Subject: Submittal of the Revised Final Project Scoping Plan for Performing a CERCLA Remedial Investigation/Feasibility Study (RI/FS) at the Radioactive Waste Burial Sites (SEAD-12) and the Miscellaneous Components Burial Site (SEAD-63)

**Comments by United States Environmental Protection Agency
(USEPA) for Seneca Army Depot
Draft-Final Seads 12&63 Project Scoping Plan
at Building 804 and the Associated Radioactive Waste Burial Sites and
the Miscellaneous Components Burial Site for the Seneca Army Depot Activity
January 1998**

SUBJECT: Response to NYSDEC Comments Dated October 27, 1999 on Background Sample Analyses for Plutonium-239/240 at SEAD-12, Seneca Army Depot Activity

Figure 4-5
Radiological Survey Decision Tree
for
Buildings 800, 802, 803, 804, 805, 806, 810, 812, 819 and 825

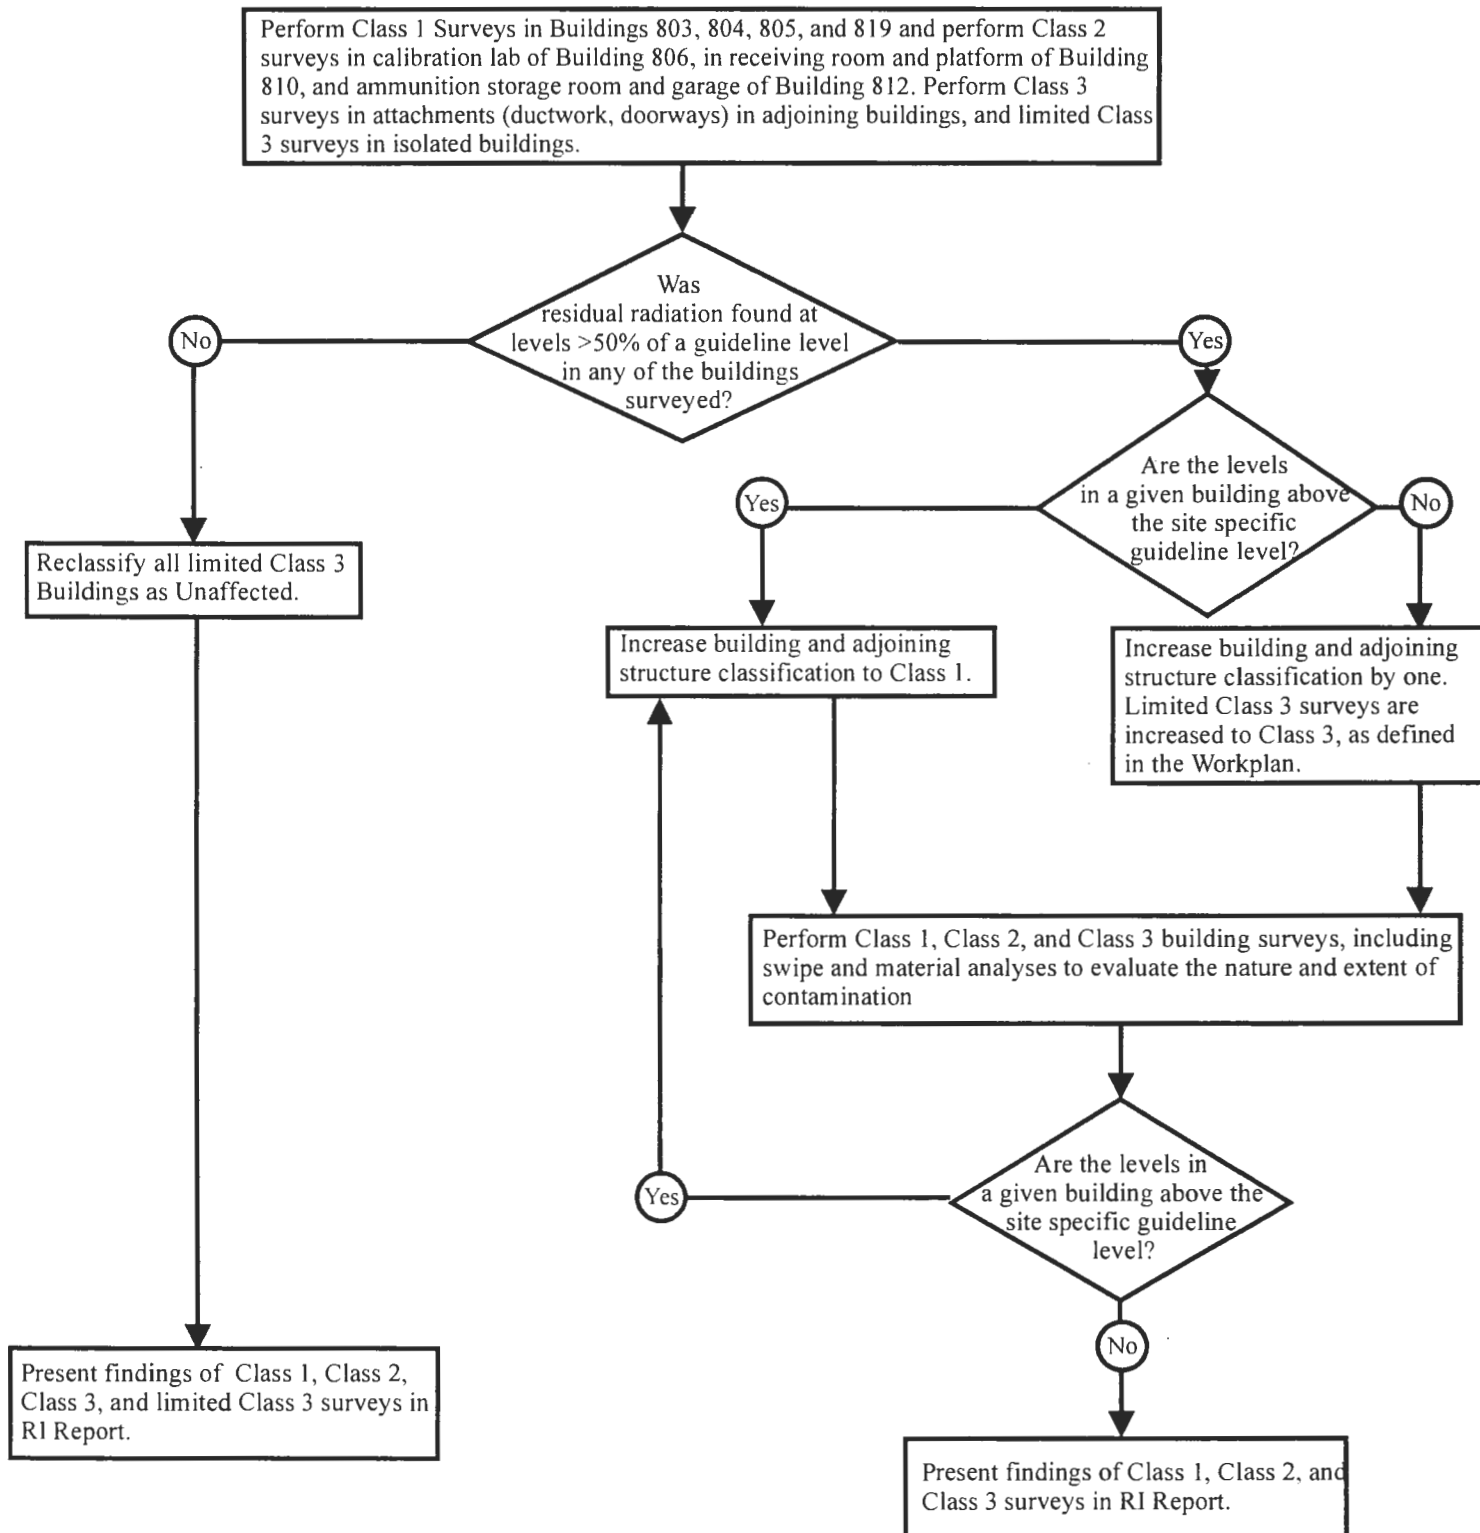
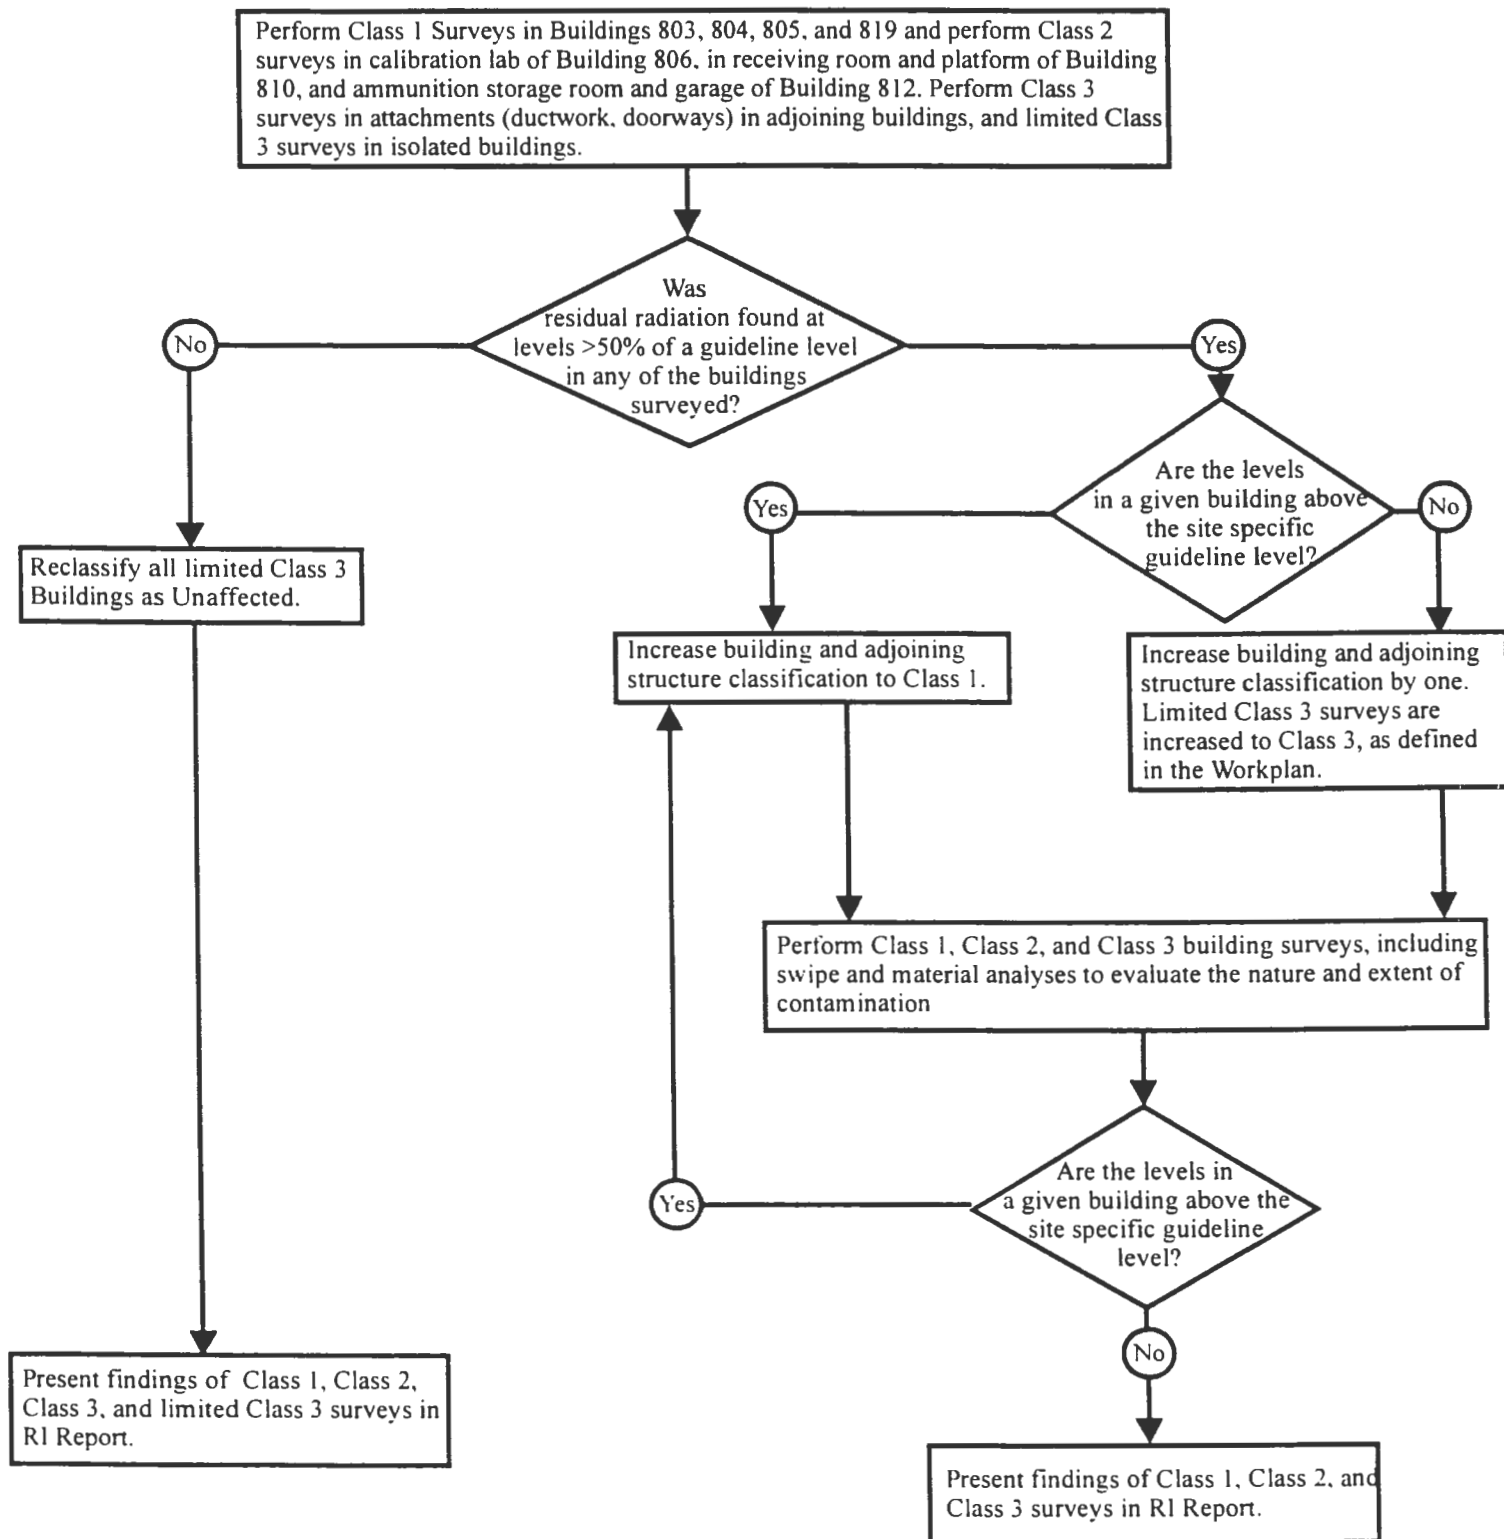
At the Albany, New York, meeting between SEDA, EPA and the NYSDEC on June 26, 1997, the Army advocated the use of a phased approach to implement the Remedial Investigations for SEADs 12 and 63. A phased approach has been incorporated in the revised Work Plan by initially identifying survey classifications in accordance with MARSSIM. A) The revised Work Plan should discuss details on how decisions will be reached to change a survey classification or implement additional phases of investigation. B) It should also be clarified if the implementation of any portion of the scope of work described in the revised Work Plans is intended to be optional or dependent upon the results of earlier phases of the revised Work Plan scope.

A) Disagree. The Final Project Scoping Plan already detailed the Army's phased approach on page 4-10 and in the decision trees on pages 4-12 and 4-13 (Figures 4-4 and 4-5). These decision processes, which include the thresholds that will trigger individual actions, explain how the initial work performed in Class One and Class Two areas will be used to decide whether the remaining areas should be reclassified or not. This approach was discussed and agreed to in formal meetings and telephone conferences between the Army, the USEPA, and NYSDEC. During these meetings, it was explained that each area or room within a given structure was used for a specific function, and that each of the activities in each area were highly controlled. The phased survey approach proposed herein provides for a high degree of effort to be expended in those few areas where the potential for radiological contamination is higher, while providing a mechanism to either upgrade (if a release is found to have occurred) or downgrade (if no evidence of a release is found) the level of effort in those areas where there is currently no data, but that had no probability, or only a very small probability, of being contaminated with radioisotopes. This phased approach allowed the Army to program a large scope investigation, while still providing a means to save costs from potentially unnecessary efforts in areas with little to no probability of being contaminated. This is the intent of the Army's use of a phased approach to performing this RI. Note that although the Army's original phased approach has not been changed, the explanation above has now been included in the document (in Section 4.2.3, Radiological Surveys at SEAD-12) to explain why this proposed approach deviates from that prescribed in MARSSIM.
